X-TYPE

XT501-21

TECHNICAL BULLETIN

Premature Front Seat Backrest Wear On Classic Style Seats – Outer Bolster Support Wire – Modification Procedure

ILLUSTRATION 1

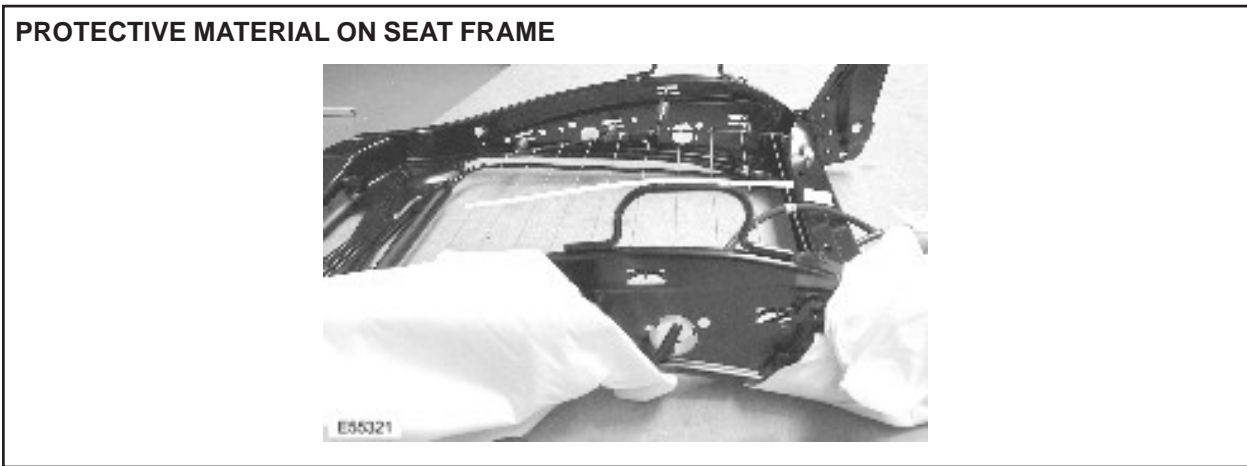
7. Place a suitable protective material over the upper part of the seat frame and the recline motor on the outboard side (Illustration 1).

ILLUSTRATION 2

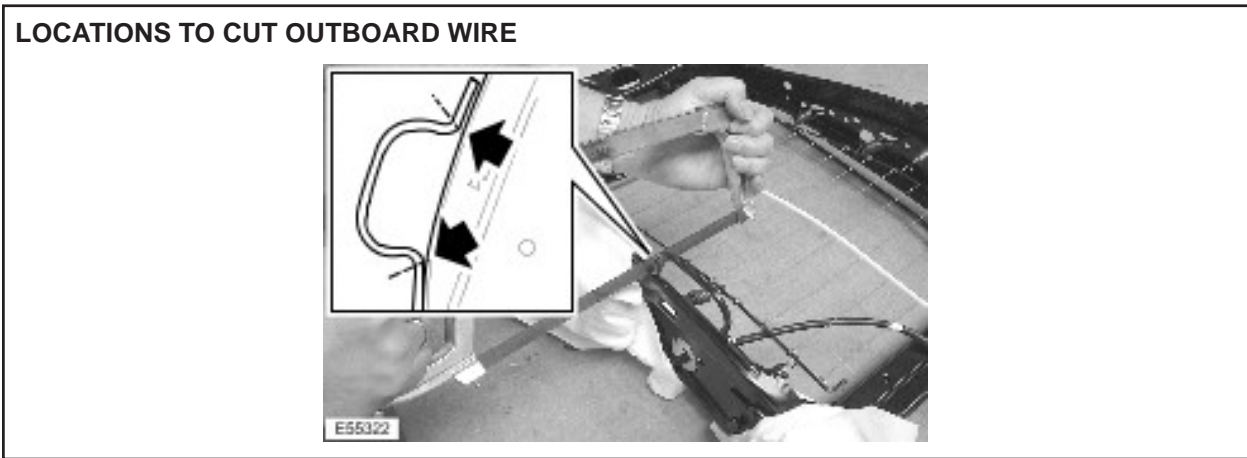
8. Cut through the outboard wire in two places as close to the frame as possible and place cut wire aside (Illustration 2).

ILLUSTRATION 3

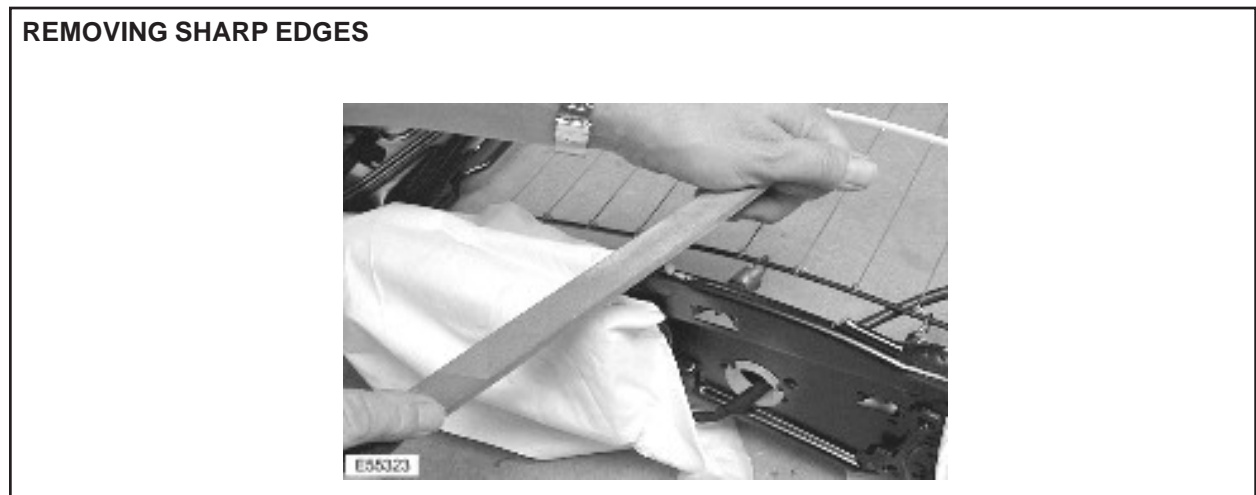
9. De-burr the cut wire ends on the frame making sure to remove all sharp edges and extra material. Clean away any debris from the frame (Illustration 3).

ILLUSTRATION 4

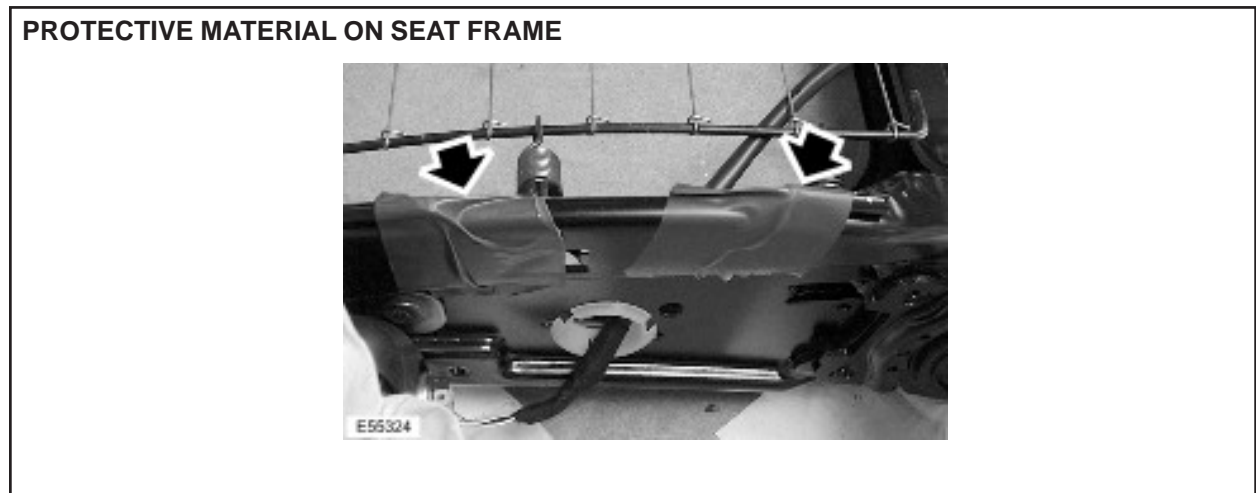
10. Remove the protective material from the frame.
11. Apply a suitable adhesive tape over the cut wire area of the frame (Illustration 4).
